ADDENDUM No. Four (4)

IFB No. 2021-239

CONSTRUCTION, COLLIN COUNTY ADULT DETENTION FACILITY, PHASE 1 ADDITION

DATE: AUGUST 20, 2021

1 MECHANICAL PIPING FLOW DIAGRAM
NOT TO SCALE

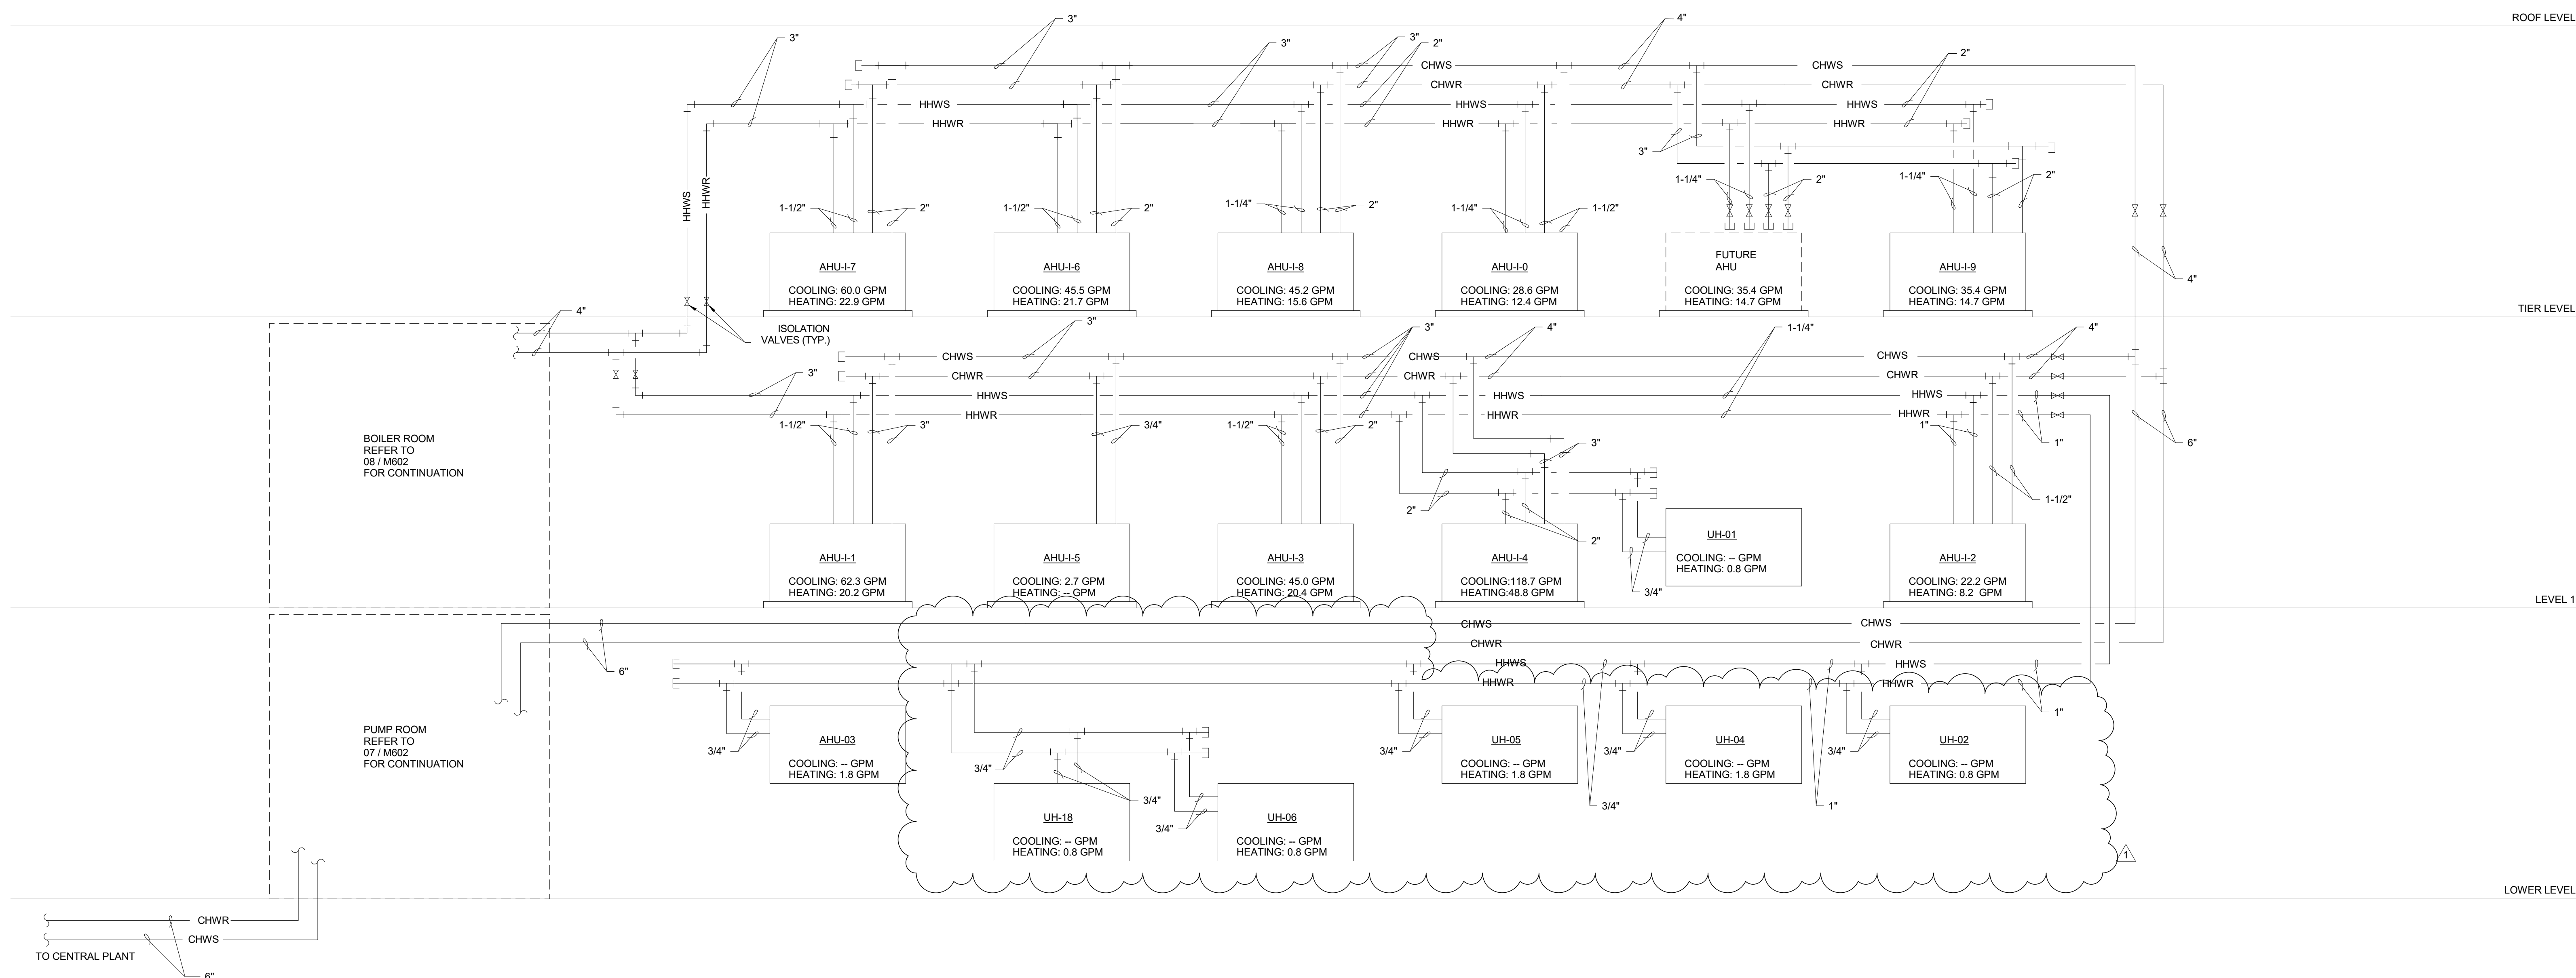
- Item No. 48. Sheet – M501**
- A. MDE Revision: Revised Mechanical Piping Flow Diagram for added UH-18.
- Item No. 49. Sheet – M503**
- A. MDE Revision: Added Flow Diagram – AHU. Revised control points matrix.

21913
07/13/2021 **S202**

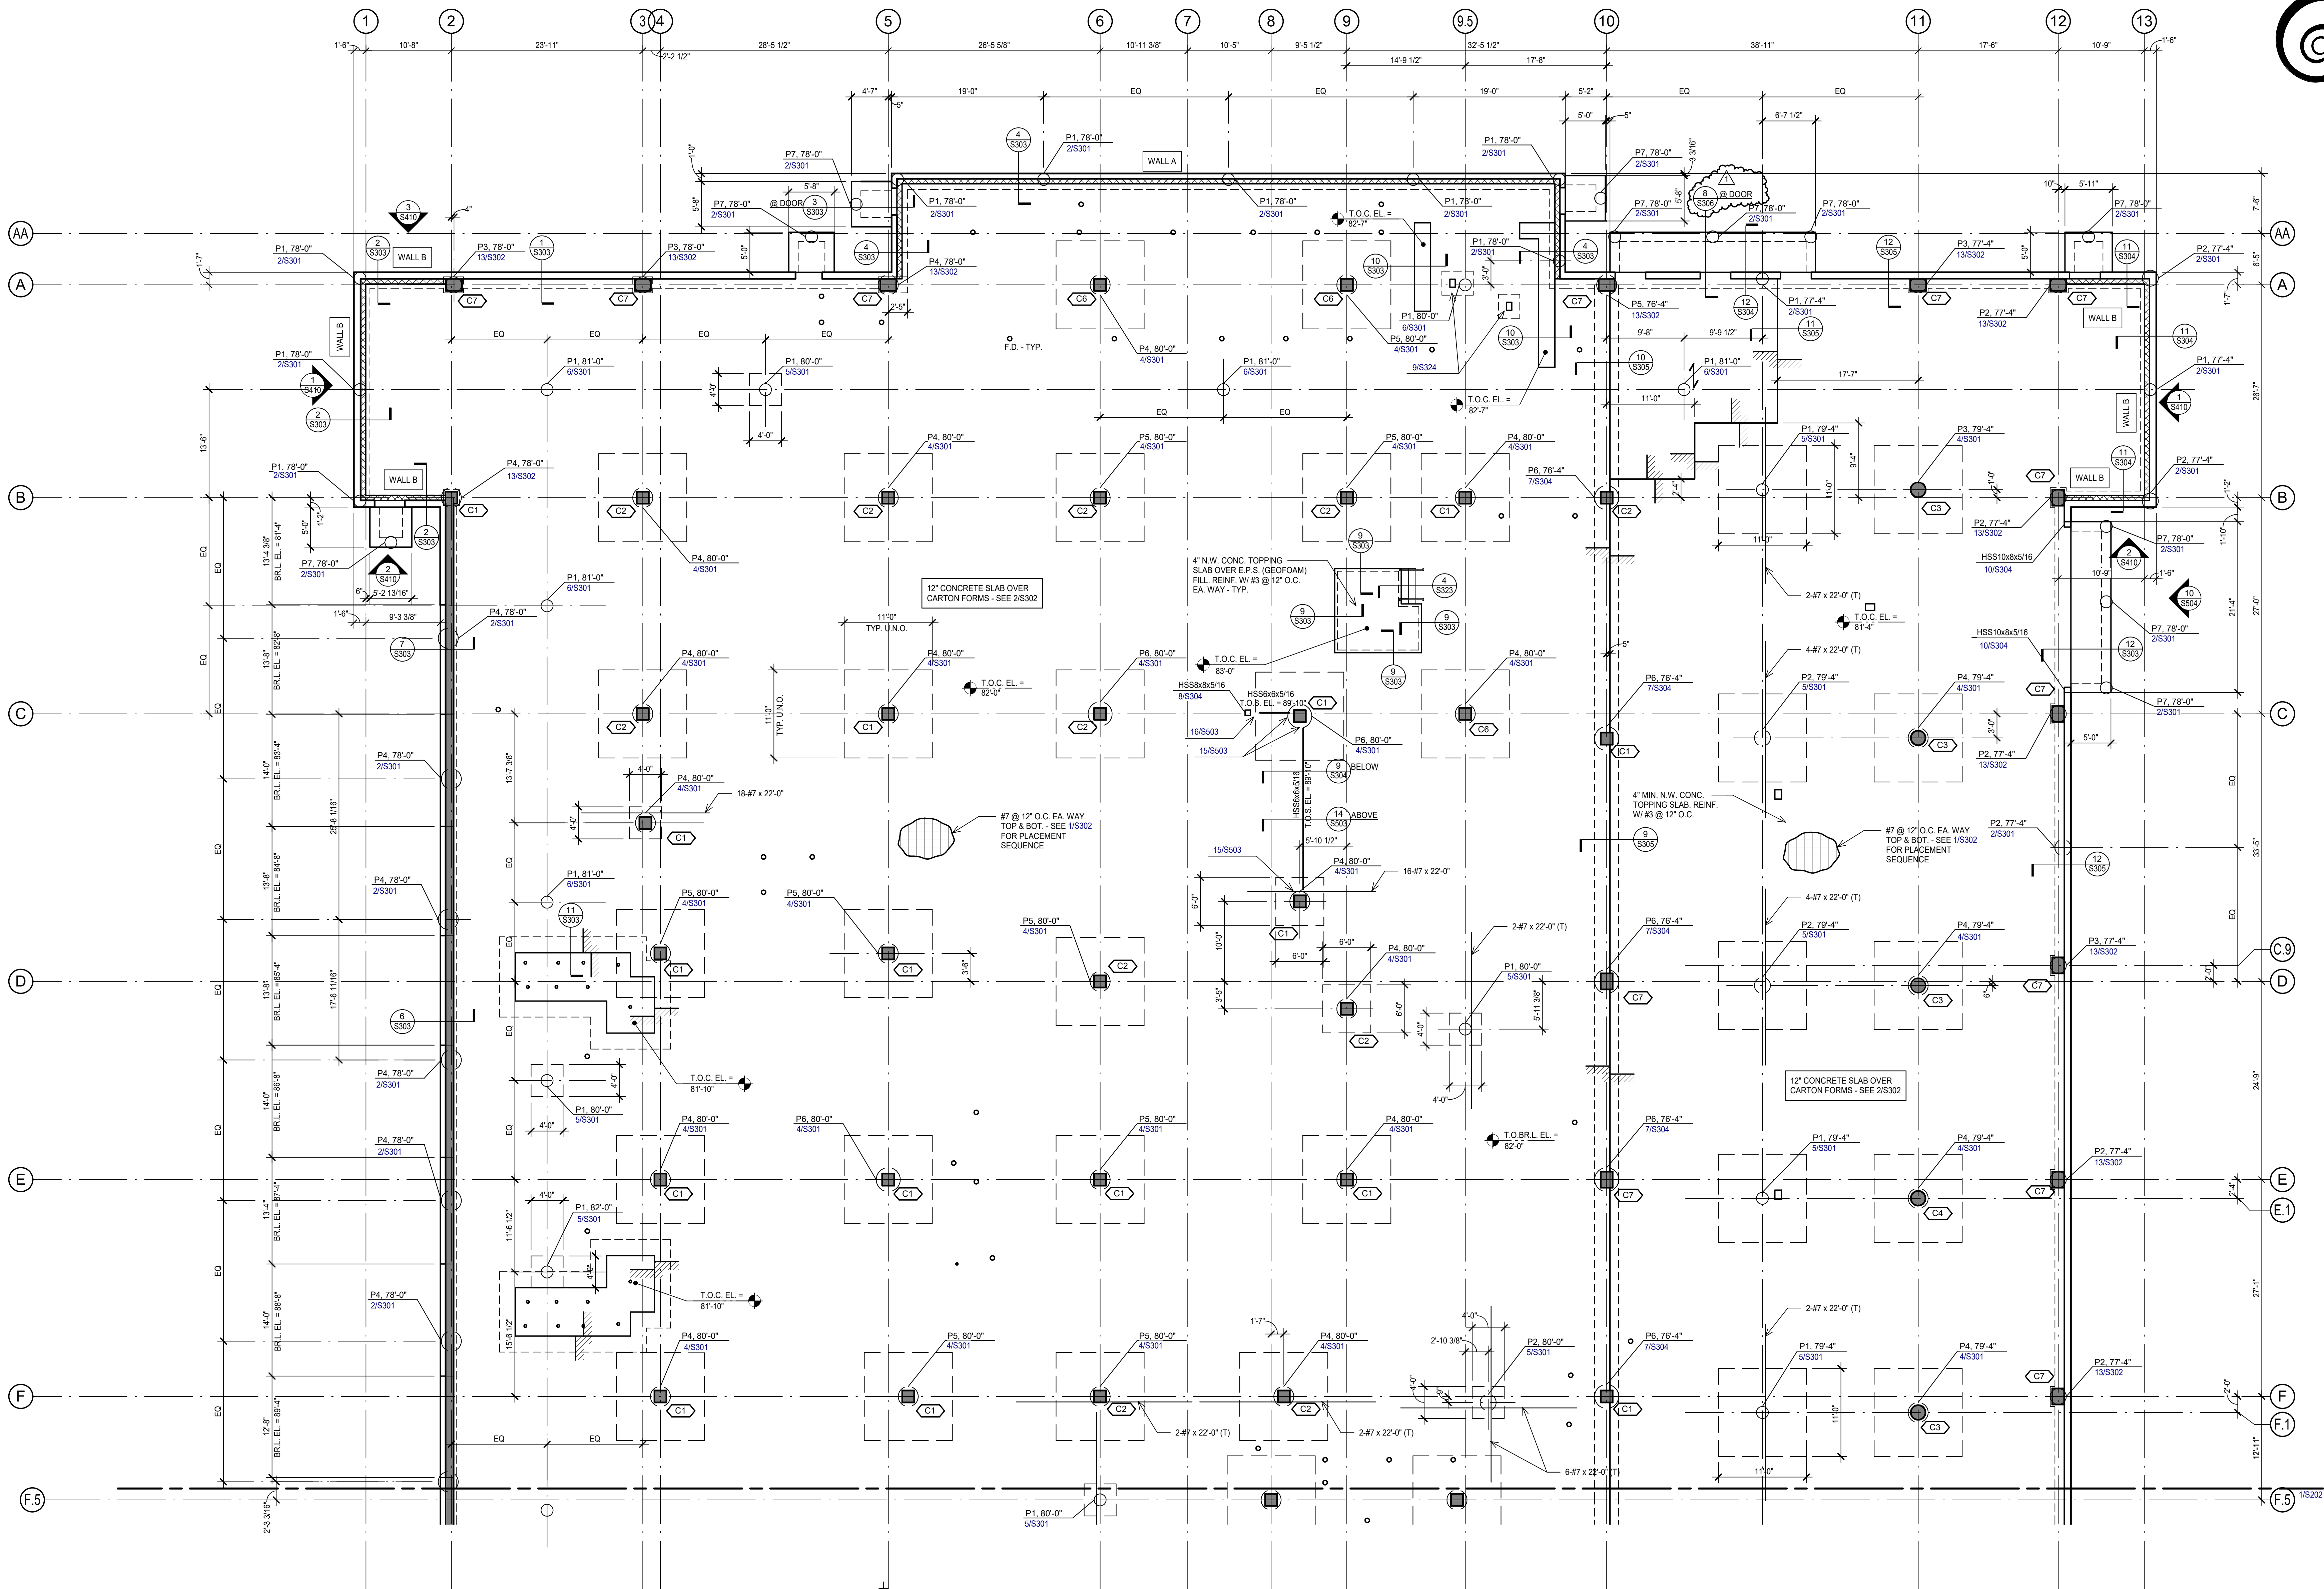
- Item No. 12. Sheet – S202**
 - A. Stoop detail at grid l updated.
 - B. Slab callout on plan 2 was updated.
- Item No. 13. Sheet – S211**
 - A. Slab callout at grid c was updated.
